Addendum No. 8

Reference: Beverley Taylor Sorenson Center for the Arts
Southern Utah University – Cedar City, Utah
DFCM Project No. 12218730

Subject: **Addendum No. 8**

| project | Southern Utah University Beverley Taylor Sorenson Center for the Arts Utah Shakespeare Festival Facility |

A1 FLOOR FRAMING PLAN - AREA B
U-SF103B SCALE: 1/8" = 1'-0"

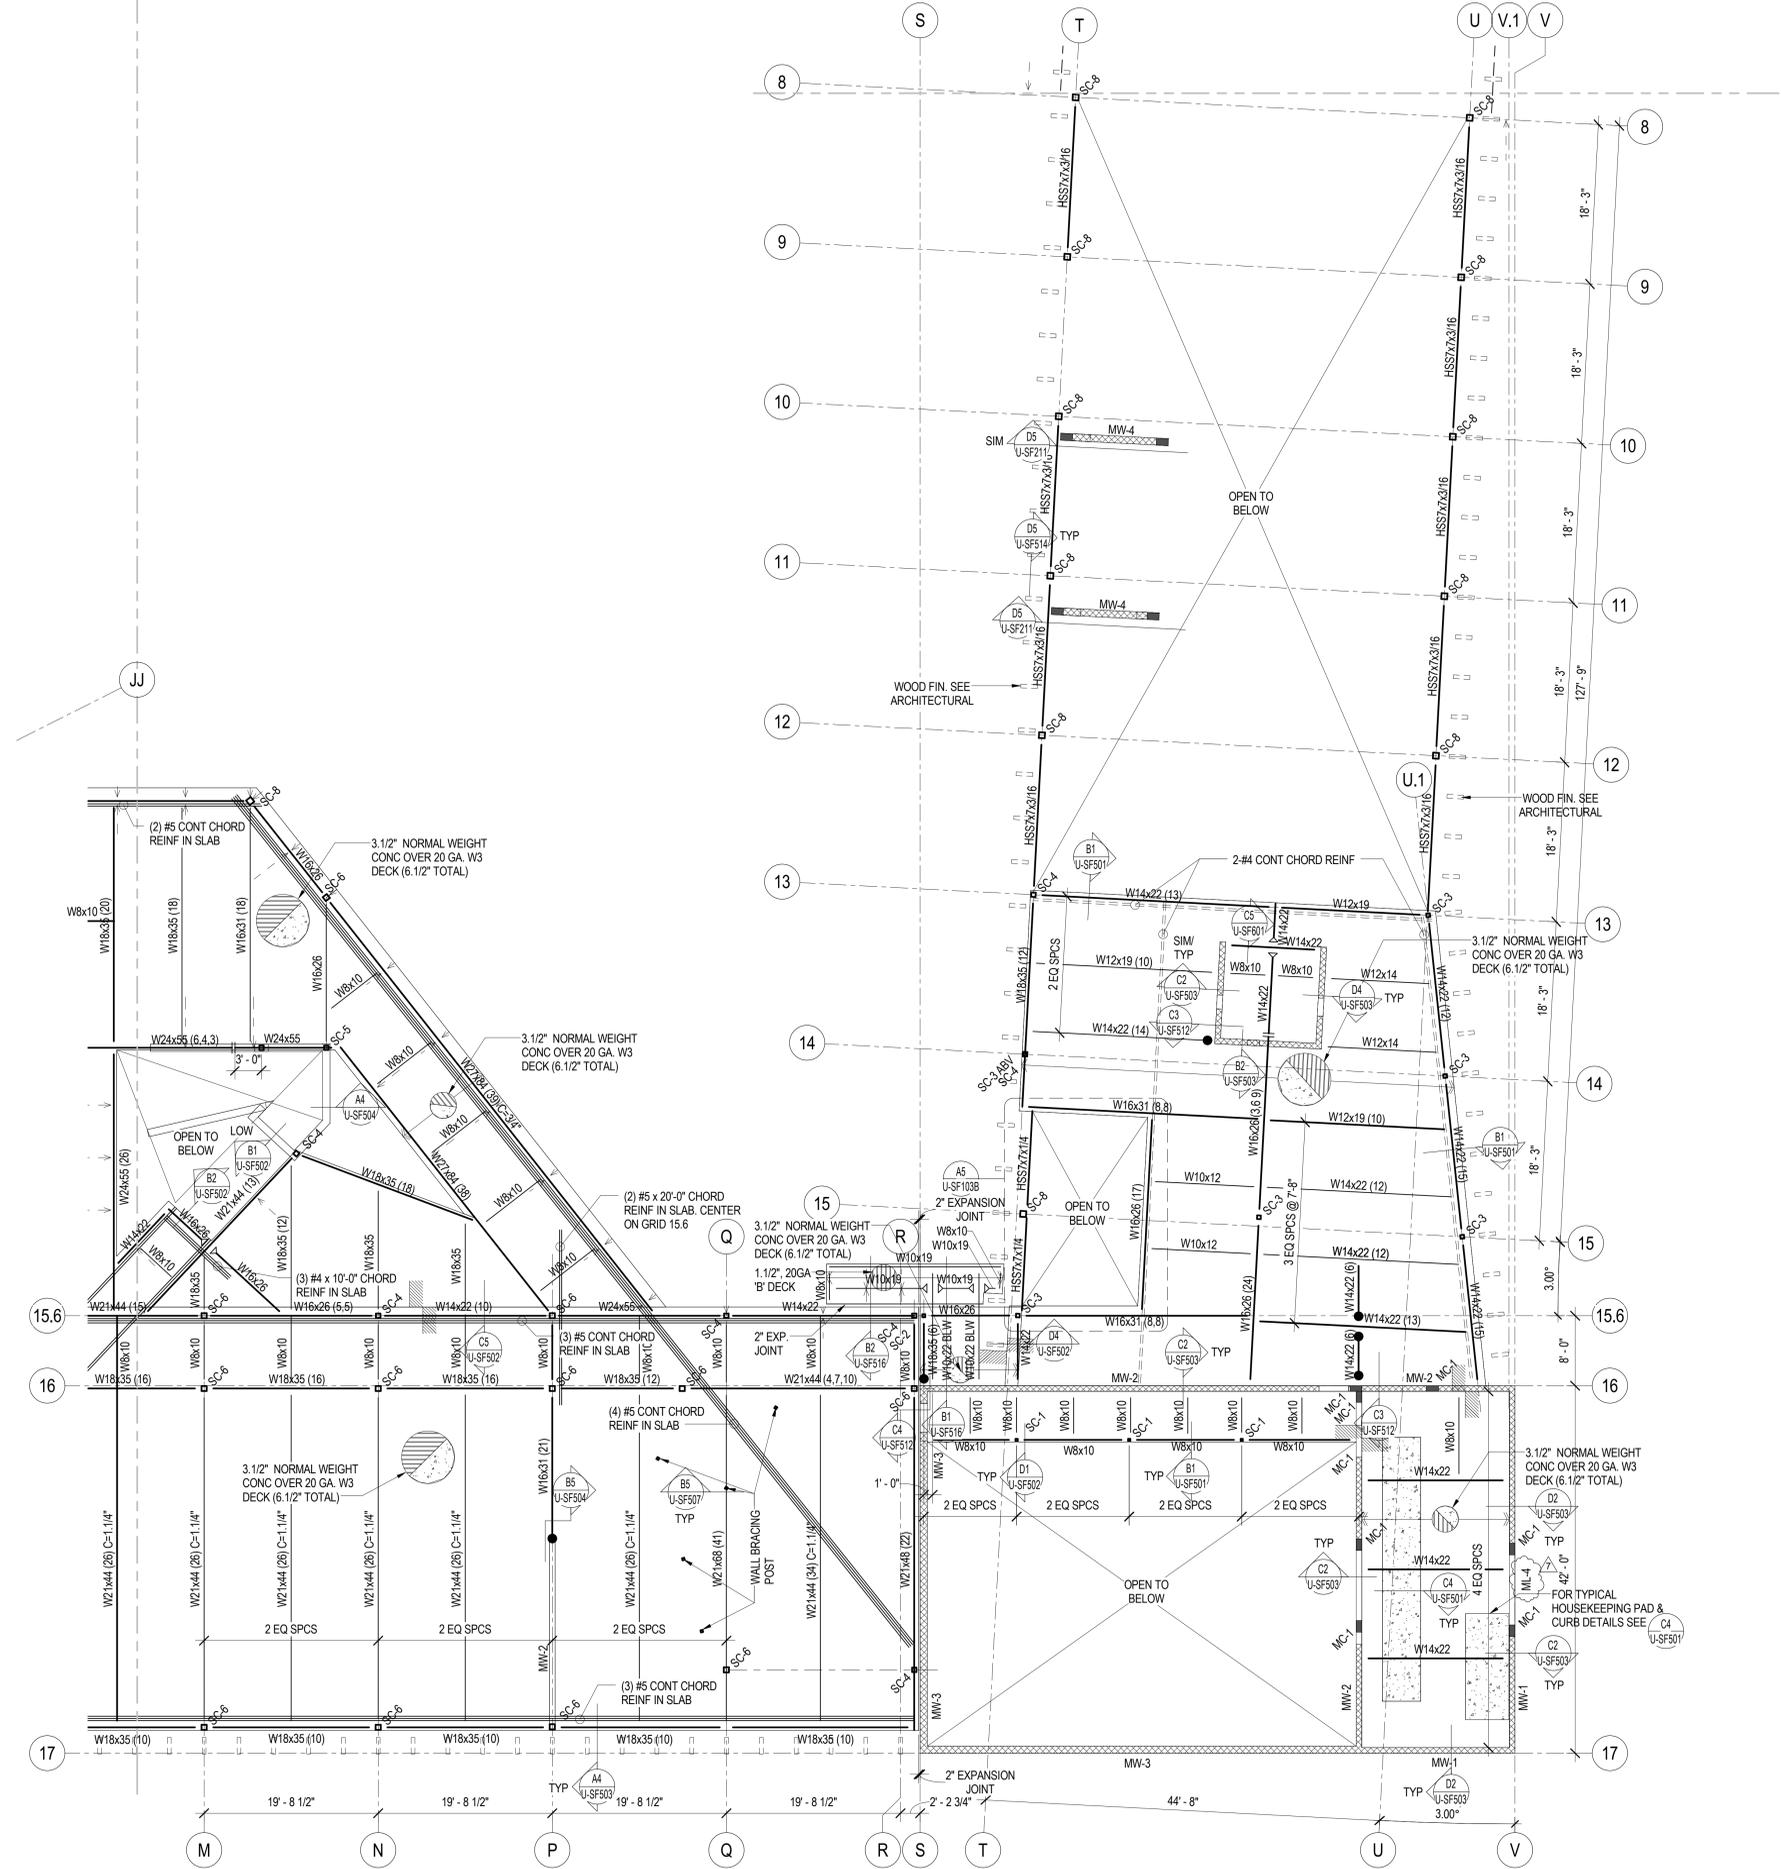
| STRUCTURAL | | | |
|-------------------------|---------------|----------|---|
| | Clarification | U-SF103B | Added masonry lintel callout. |

First Floor Mech
Plan - Area A
U-M101A

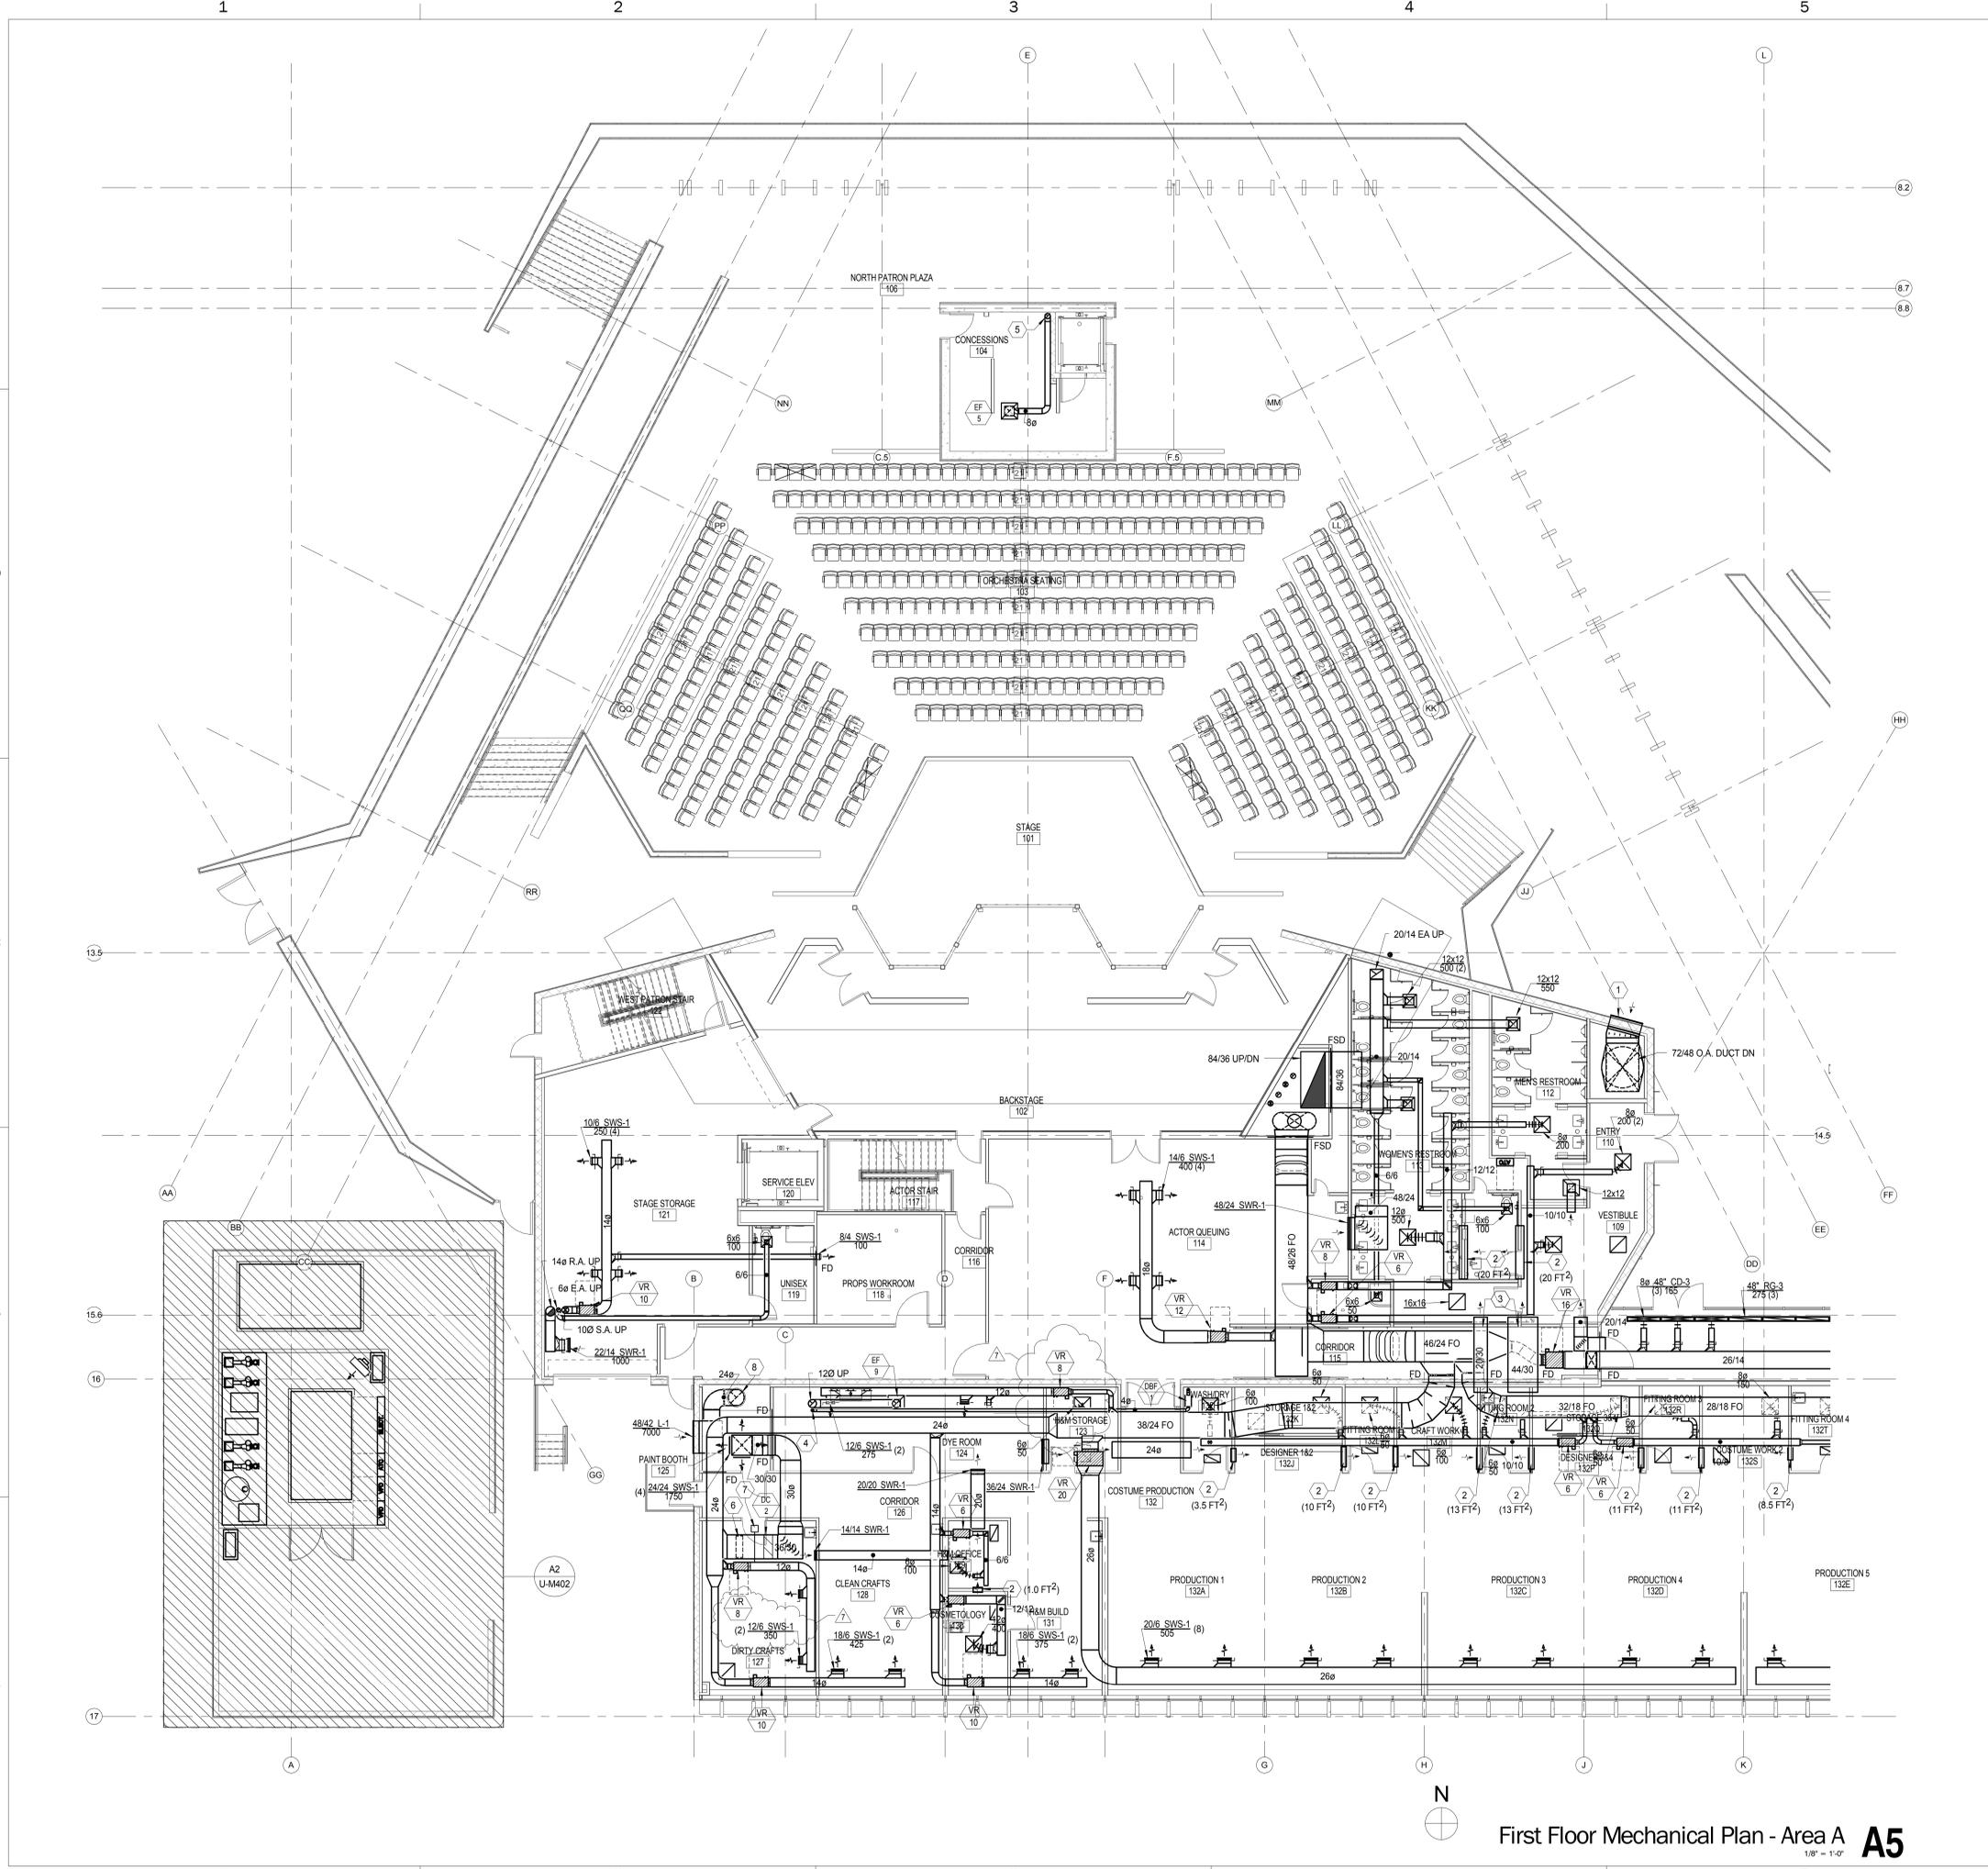
| STRUCTURAL | | | |
|-------------------------|---------------|----------|---|
| | Clarification | U-M101A | <ul style="list-style-type: none"> The following item was changed in Addendum #03 but was not updated on the conformed set: "Dye Room 124 VAV Box shall be VR-8 in lieu of VR-6." See revised drawing. |

| | Clarification | U-M101A | <ul style="list-style-type: none"> The following item was changed in Addendum #05 but was not updated on the conformed set: "Refer to Dirty Crafts 127: Provide and install two 12"x6" side wall supply grilles, type SWS-1, in lieu of two ceiling supply diffusers. Balance each grille to 350 CFM." See revised drawing. |

Basement
Plumbing Plan
U-P100

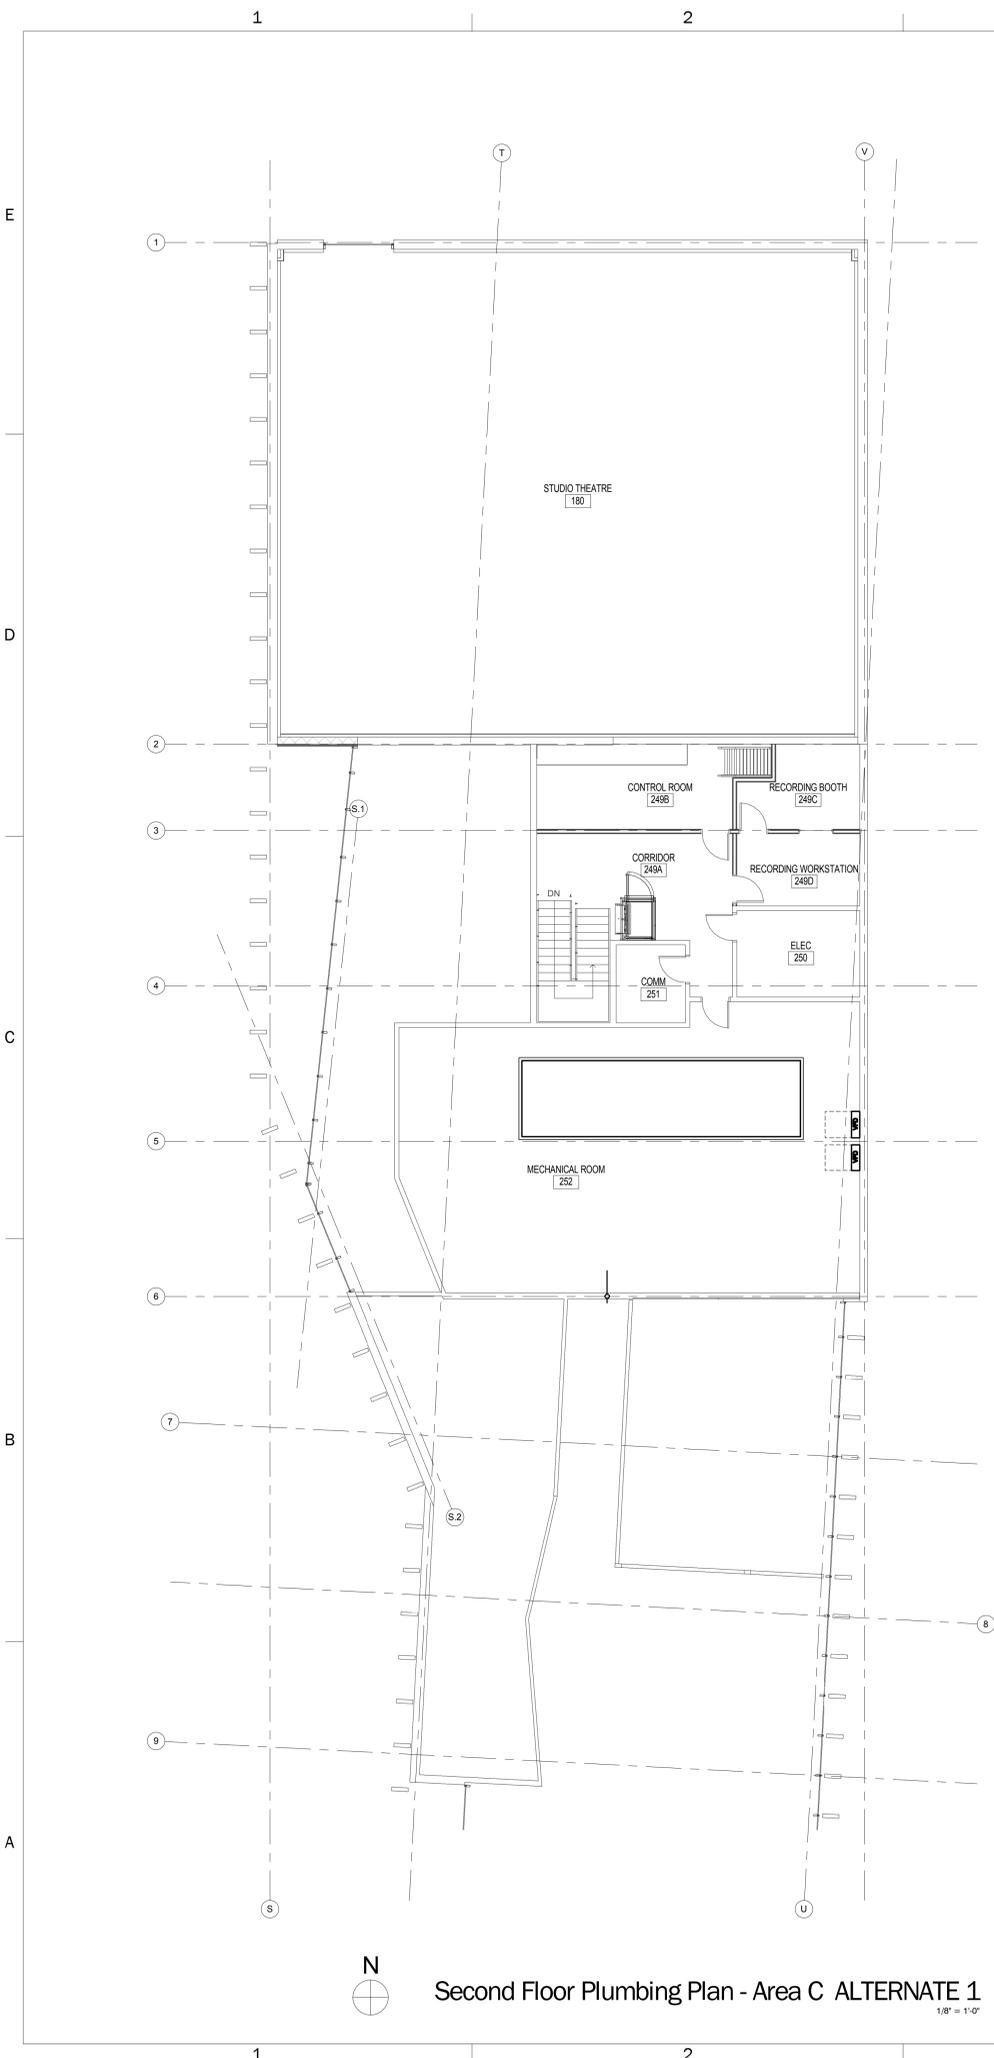
| STRUCTURAL | | | |
|-------------------------|---------------|----------|---|
| | Clarification | U-P100 | <ul style="list-style-type: none"> The following item was changed in Addendum #03 but was not updated on the conformed set: "Water Header shall be labeled with detail callout C5/U-P501. See revised drawing. |
| | Clarification | U-P100 | <ul style="list-style-type: none"> The following item was changed in Addendum #03 but was not updated on the conformed set: "Keyed note 5 shall apply to below grade vent piping in concessions storage 006. See revised drawing. |
